Town of Ramapo
Building, Planning and Zoning Department

COMMUNITY DESIGN REVIEW COMMITTEE

June 04, 2025, Revised July 7, 2025

2024.008: 1551 Route 202 Site Development Permit
1551 Route 202, Pomona
Tax Lot 33.05-2-9
Zoning: CC zoning district

LAYOUT PART PLAN

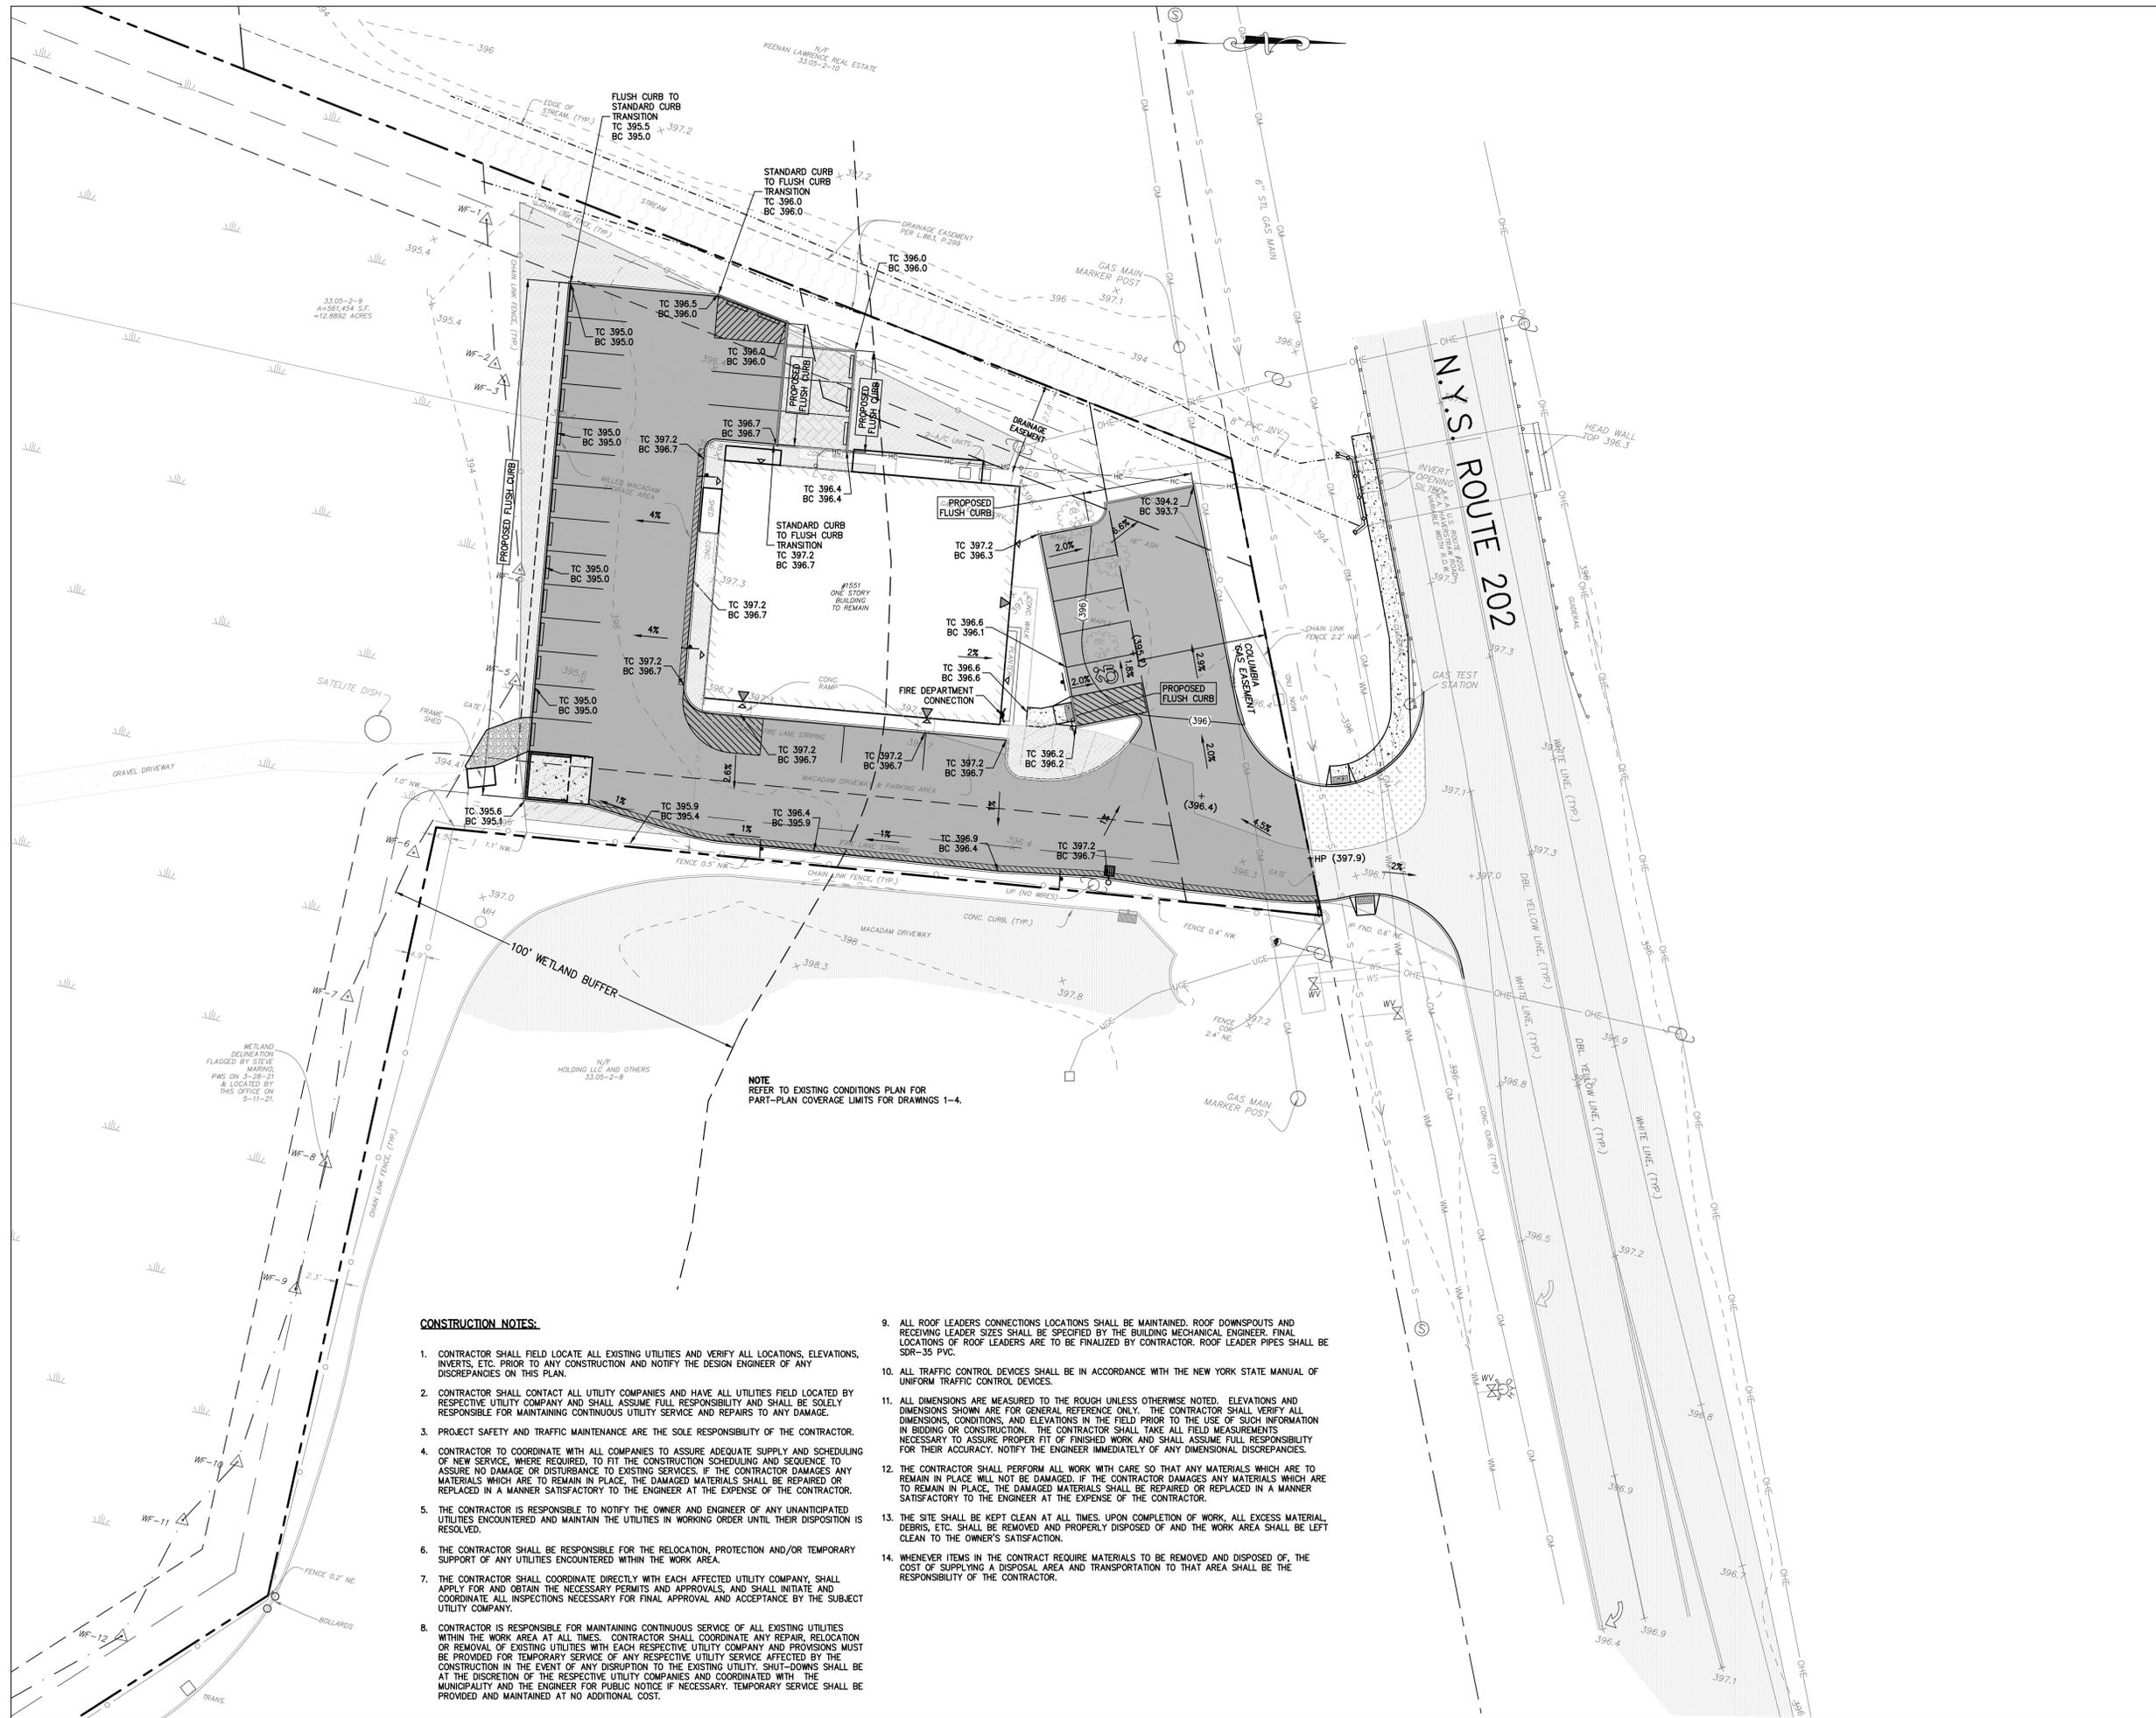
11. *COMMENT: Provide the XBA number for the requested variances if and when approved.*

12. *COMMENT: Standard Site Development Plan notes 14-20 pursuant to Section R376-605.C of the SDPRR.*

13. *COMMENT: The applicant is requesting a 28% reduction from the required minimum number of parking*

spaces. Pursuant to Section 376-70 of the Ramapo Town Zoning, the Planning Board may not exceed 25% of the normally required amount of parking spaces. A variance from the ZBA will be necessary. The narrative mentions a parking study that was conducted to support the reduced parking, but none was provided with the submission.

14. *COMMENT: The proposed parking spaces appear to be within the side yard setbacks, which is not permitted per Section 376-50 of the Town Code.*

15. *COMMENT: The development proposed work within the NYSDEC wetland 100-foot adjacent area. The applicant shall provide the Town with a copy of the Article 24 Permit which shall be done prior to check print approval.*

16. *COMMENT: Provided the time frame and individual who performed the wetland delineation.*

17. *COMMENT: The plans provide a 16-foot parking stall with a 3-foot overhang. The plans should be revised to provide the full 19-foot parking stalls. The rationale is that recent observations have shown that the diminished length of parking that utilizes this approach has become insufficient during the winter months and obstructed width due to snowfall.*

18. *COMMENT: It is uncertain how the three parking spaces on the west side of the site, designated as permeable pavement, will be accessed. Cars parked in the spaces to the south would block access these spaces. Furthermore, the plans indicate a concrete curb separating the parking spaces. Parking stalls shall be fully accessible from a drive aisle and not obstructed by other parking spaces.*

19. *COMMENT: Subsequent plans shall provide further detail, ensuring accessible routes are compliant with ADA Guidelines.*

20. *COMMENT: The current layout obstructs the gravel driveway used for antenna access. The applicant should provide additional details regarding future access to the antennas or whether the antennas will be removed as part of this application.*

21. *COMMENT: The following comments are relative to the site plan and its conformance to the International Fire Code (IFC). The Town Fire Official shall have final authority on the applicability of these comments to the proposed site layout:*

- a. *Show or note the location of any required Knox Box associated with the buildings.*
- b. *Show or note the location of any required fire department connection associated with the buildings.*
- c. *Should the on-site drive aisles be designated as fire apparatus access roads, it shall be confirmed that the pavement section meets the loading criteria of Section Appendix D, Section S102.1 of the IFC.*
- d. *Due to the proposed building use, it is assumed that the building will have automatic sprinklers. If this is correct, identify the location and size of any required hot boxes.*

Response: No variances are anticipated.

Response: The requested notes have been provided.

Response: As noted above, proposed parking has been revised, and the Application now requires 9.7% reduction by the Planning Board. No variances are anticipated. A 5/14/2025 parking study prepared by Colliers is attached.

Response: No parking is proposed in the side yard.

Response: Comment noted, no action required by Applicant at this time.

Response: The plans are labeled with the name of the wetland scientist and the date of the delineation.

Response: As discussed at CDRC, the parking stall configuration meets the site plan regulations and has been found to be acceptable for this project by the Building Inspector.

Response: The 3 subject spaces are "tandem" spaces to be used by employees who work at the facility. This arrangement has been found to be acceptable by the Building Inspector at the last CDRC meeting.

Response: ADA compliant grading is indicated on the grading plan.

Response: It is understood that the subject gravel driveway may be obstructed by a parked car. Access to the gravel driveway will be scheduled by appointment and the owner will provide unobstructed access at that time. No antenna is proposed to be removed.

TITLE: **LIGHTING AND LANDSCAPE PART PLAN**

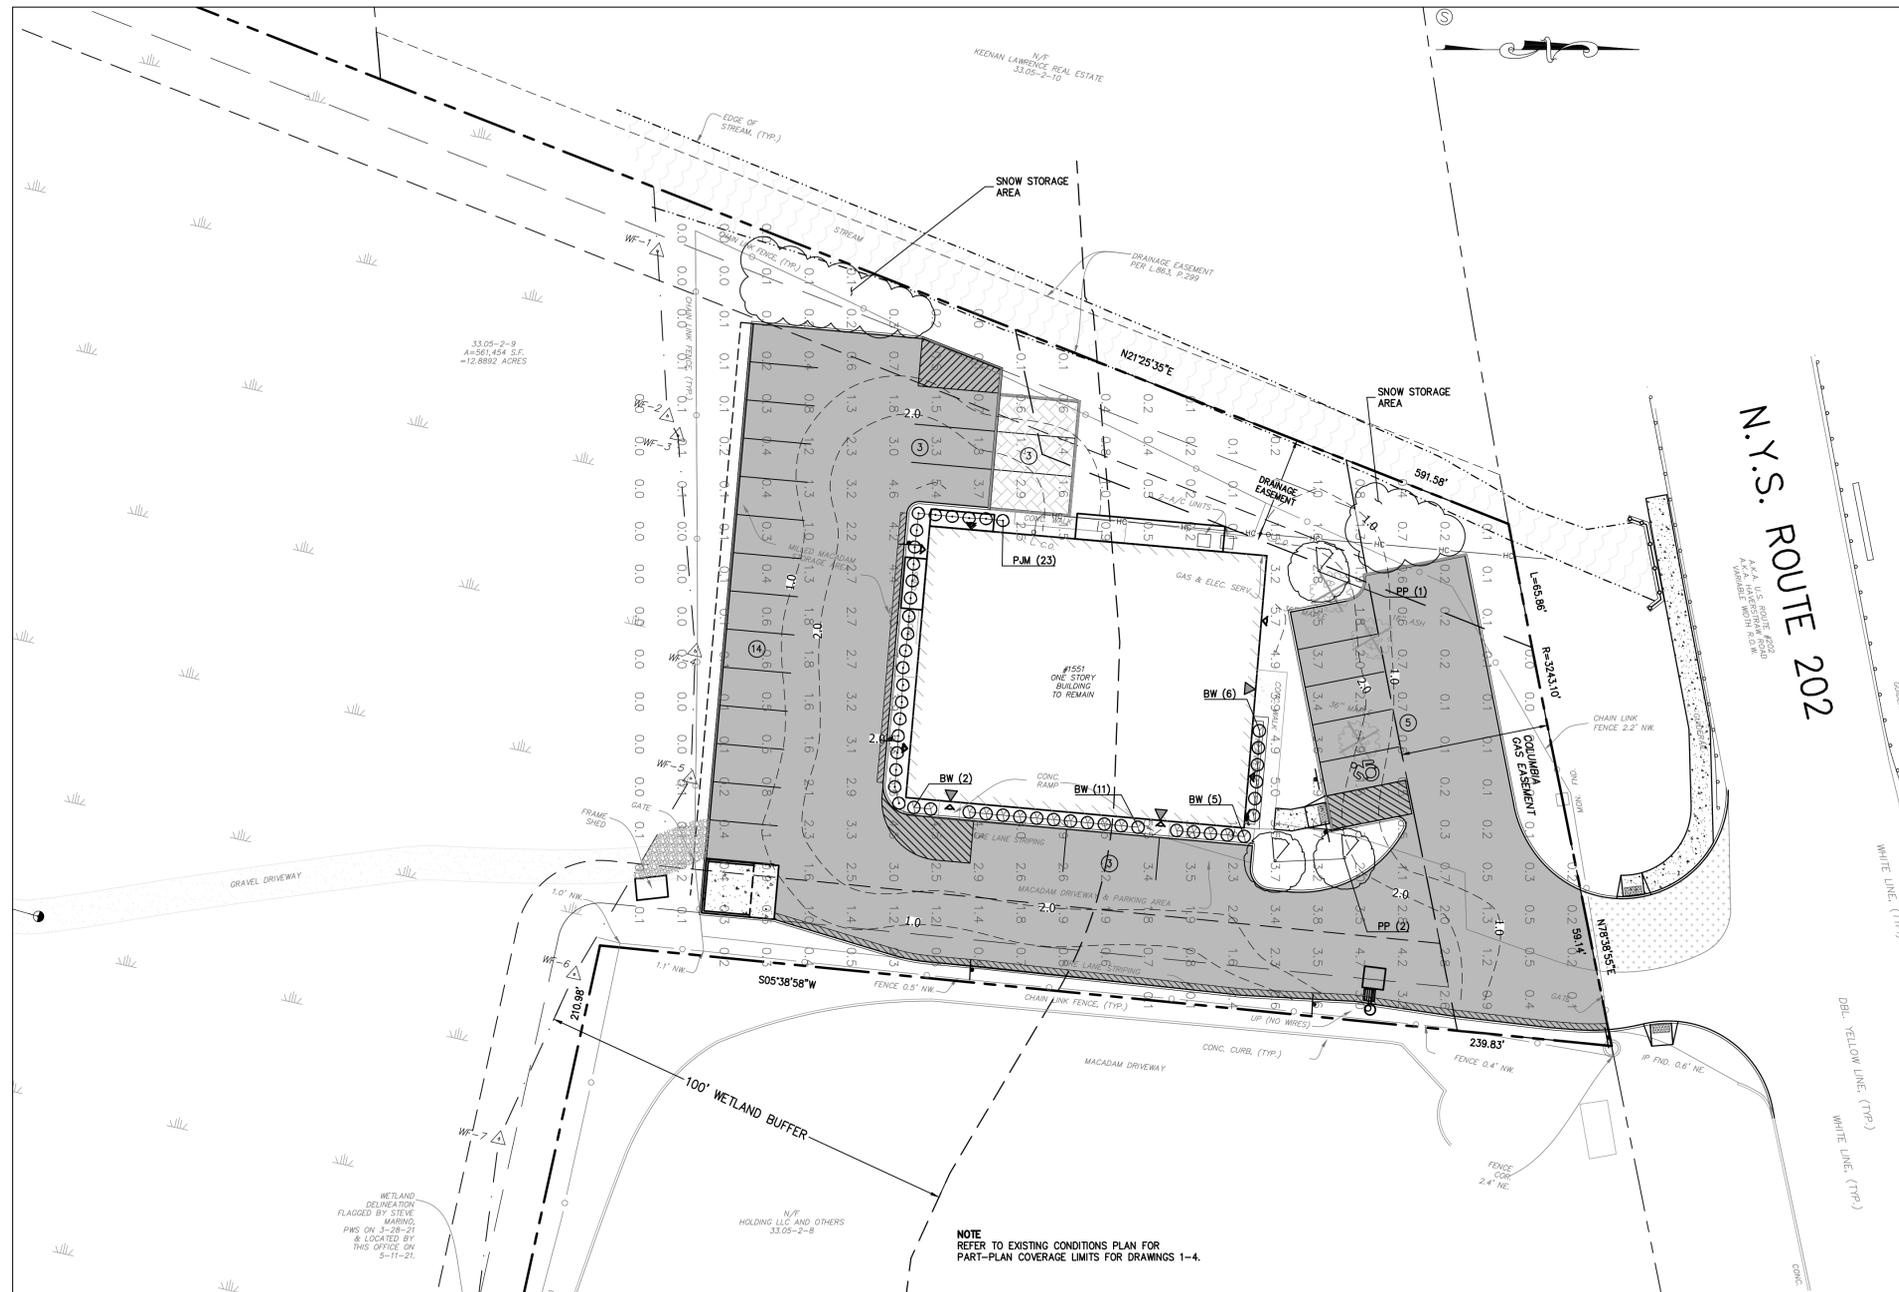
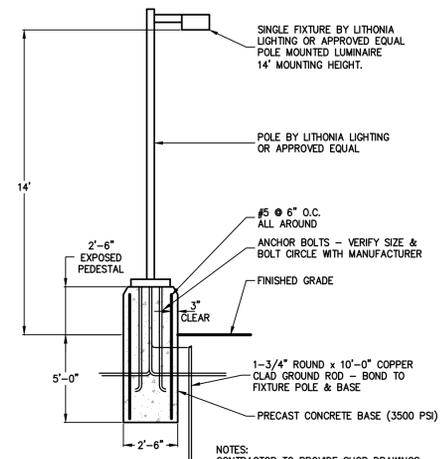
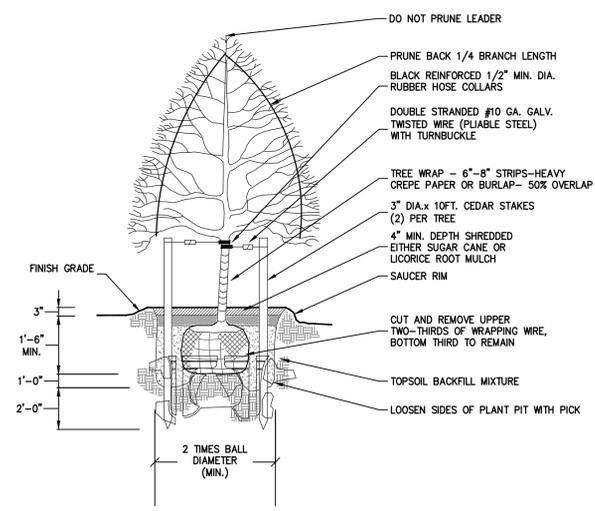
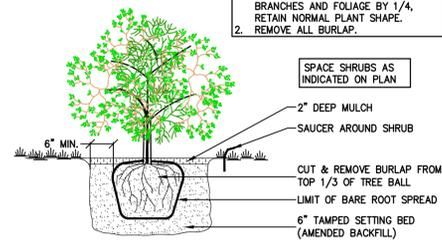
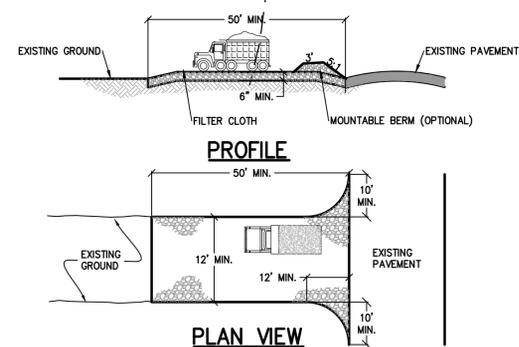
23. *COMMENT: Indicate locations for snow storage. If snow needs to be removed from the site, include a note regarding that requirement and specify the maximum time frame for removal.*

24. *COMMENT: Confirm that all above-ground structures, specifically mechanical or electrical equipment, if proposed, are shown pursuant to the Town's Site Development Plan Rules and Regulations (SDPRR)*

25. *COMMENT: Per R376-605 B. 3. d. The planting list must show both the height and caliper of proposed plantings. The plant schedule shows only the height or the caliper.*

26. *COMMENT: Update planting detail to show the 4-inch minimum depth of either sugar cane or licorice root mulch so as not to conflict with the Town's standard notes.*

27. *COMMENT: The "Deciduous Tree Detail" calls out, "remove an upper third of wrapping wire..."; the callout should say remove "upper two-thirds of wrapping wire, bottom third to remain."*

28. *COMMENT: The "Shrub Planting Detail" Note 2 should say, "Remove all burlap."*

29. *COMMENT: Provided Landscaping notes pursuant to Section R376-605.B.3.e of the SDPRR*

30. *COMMENT: Pursuant to Section R376-607.B of the SDPRR, parking lots shall have an average of 1.0 foot-candles. The isometrics shown seem well above 1.0 foot-candles in much of the parking area. Subsequent submissions shall update the proposed lighting layout to ensure the minimum and maximum foot-candle values are being provided pursuant to Section R376-607.B of the SDPRR.*

31. *COMMENT: Provided a light pole detail.*

Response: Snow storage location is indicated.

Response: A placeholder location is indicated for future mechanical or electrical equipment needs which are unknown at this time.

Response: Planting Plan convention is to specify deciduous plants by caliper and evergreen by height.

Response: The tree detail callout has been revised as requested.

Response: The shrub planting note has been revised as requested.

Response: The subject landscaping notes have been provided.

Response: The lighting plan has been revised and provides an average of 1.32 footcandles that provides thoughtful and appropriate illumination at key locations and meets the spirit of the SDPRR.

Response: A light pole detail has been provided.
